# Access Compliance Report

## Public Rights-of-Way (Curb Ramps)

Intersection ID: 50602	Main Street: RHODORA_RD	Cross Street: CEDARFIELD_RD	Location: SE
ADA ID: 236952148274	Ramp Type: Perp	Initial Pass/Fail: Fail	Overall Compliance: No
		Severity Score: 35

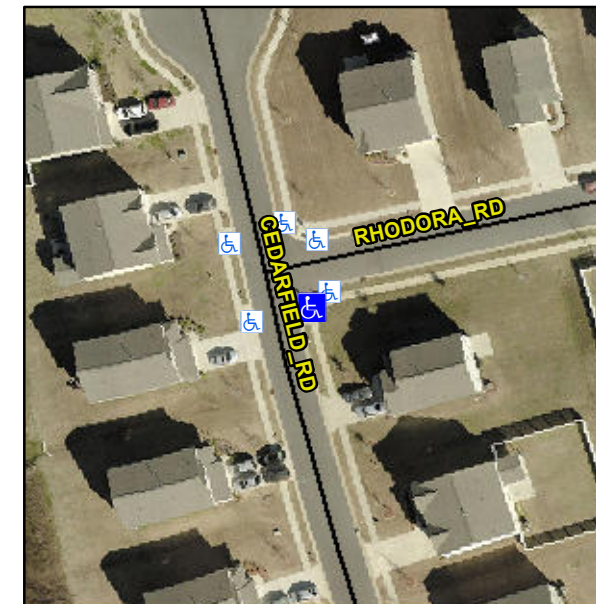
**Not Found, R304.5.1, R304.2.2, R304.5.3**

Compliance	Description	Data	Compliance	Description	Data
N/A	Ramp Length (in)	47.0	No	Ramp Slope (%)	15.7
No	Ramp Width (in)	47.5	No	Ramp XSlope (%)	2.6
N/A	Flare Type LT	N/A	N/A	Flare Type RT	N/A
N/A	Flare Slope LT (%)	N/A	N/A	Flare Slope RT (%)	N/A
N/A	Flare Traversable LT?	N/A	N/A	Flare Traversable RT?	N/A
N/A	Landing Length (in)	N/A	N/A	DWS Provided?	N/A
N/A	Landing Width (in)	N/A	N/A	DWS Contrast?	N/A
N/A	Landing Slope (%)	N/A	N/A	DWS Length (in)	N/A
N/A	Landing X Slope (%)	N/A	N/A	DWS Full Width?	N/A
N/A	Landing Curb? (Y/N)	N/A	N/A	DWS Offset (in)	N/A
N/A	Shared Landing?	N/A			
N/A	Gutter Ponding?	N/A	N/A	Gutter Slope (%)	N/A
N/A	Gutter Lip Ht (in)	N/A	N/A	Gutter X Slope (%)	N/A
N/A	Painted X Walk1?	No	N/A	Painted X Walk2?	N/A
	X Walk 1 Direction	To W		X Walk 2 Direction	N/A
N/A	X Walk 1 Width (in)	N/A	N/A	X Walk 2 Width (in)	N/A
	X Walk 1 Slope (%)	2.8		X Walk 2 Slope (%)	N/A
	X Walk 1 X Slope (%)	2.2		X Walk 2 X Slope (%)	N/A

**Remove & Replace Entire Ramp.**
